# Brocade Fabric OS v5.0.4a Release Notes v1.0

April 14, 2006

Fabric OS v5.0.4a is a patch release containing fixes to defects found since the release of Fabric OS v5.0.4. Aside from these fixes, this patch release includes the same feature set as Fabric OS v5.0.4.

**Figure 12-1** FICON CUP Management, Port Based Routing.

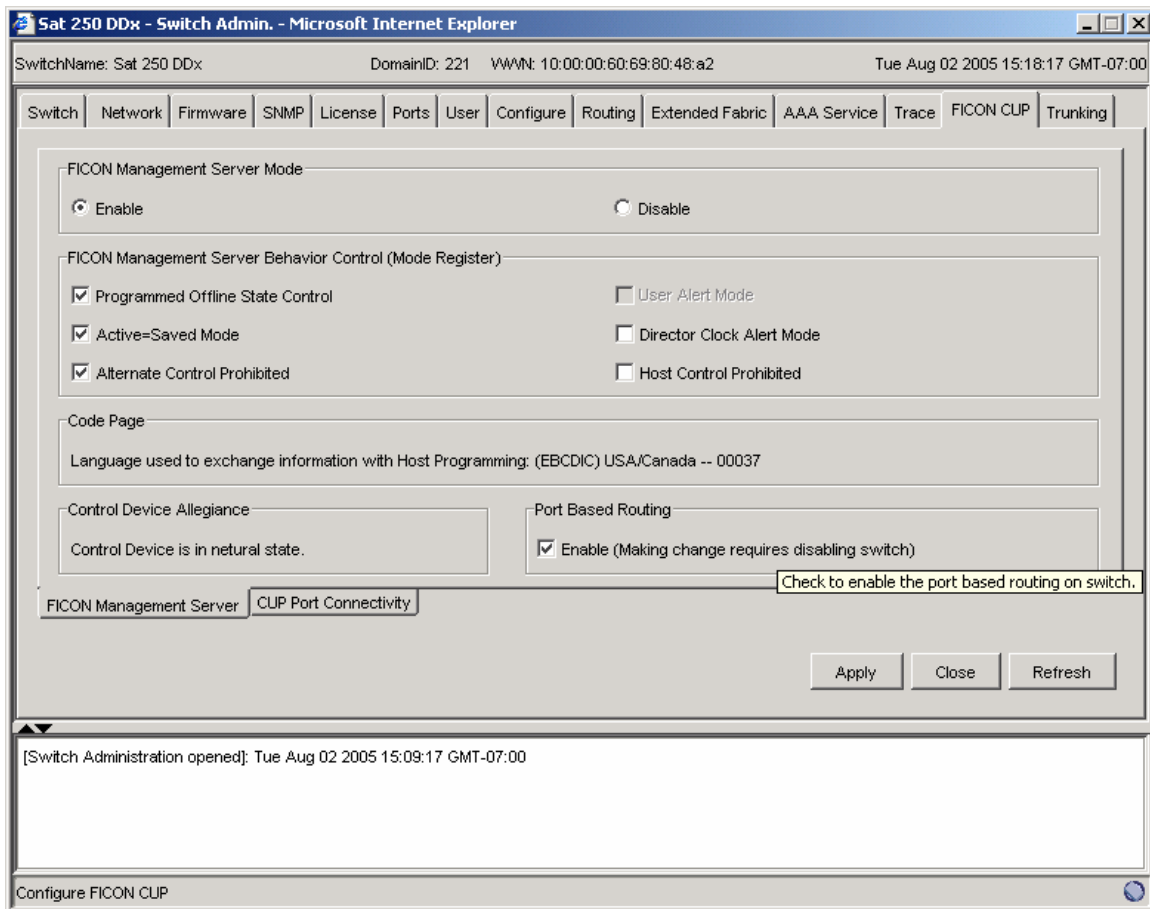
In Chapter 12, “Administering FICON CUP Fabrics,” on page 12-1, add a new section “Enabling Port Based Routing”

4. Click the **Enable** radio button to enable the port-based routing policy.

**Figure 14-1** Accessing Performance Graphs

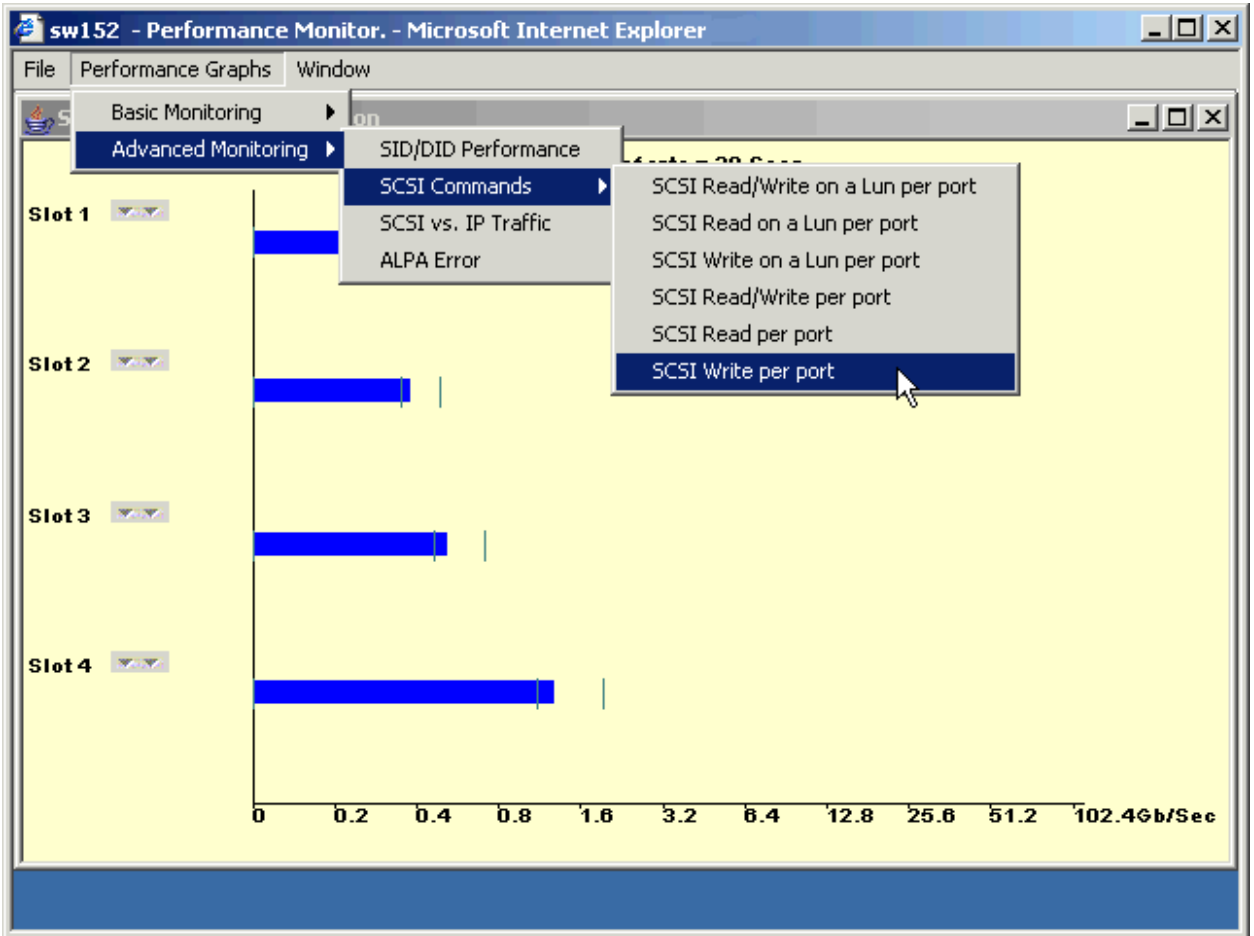
On page 14-3, replace Figure 14-1 with this one:

Port throughput utilization is represented by a horizontal bar for each selected port, which gets longer or shorter depending on the percent utilization for that port at the last poll time. Thin short vertical intersecting bars give a historical perspective by representing the highest and lowest values reached for each selected port since the graph was opened. A third bar between them represents the average of all values polled. (See Figure 14-1.)
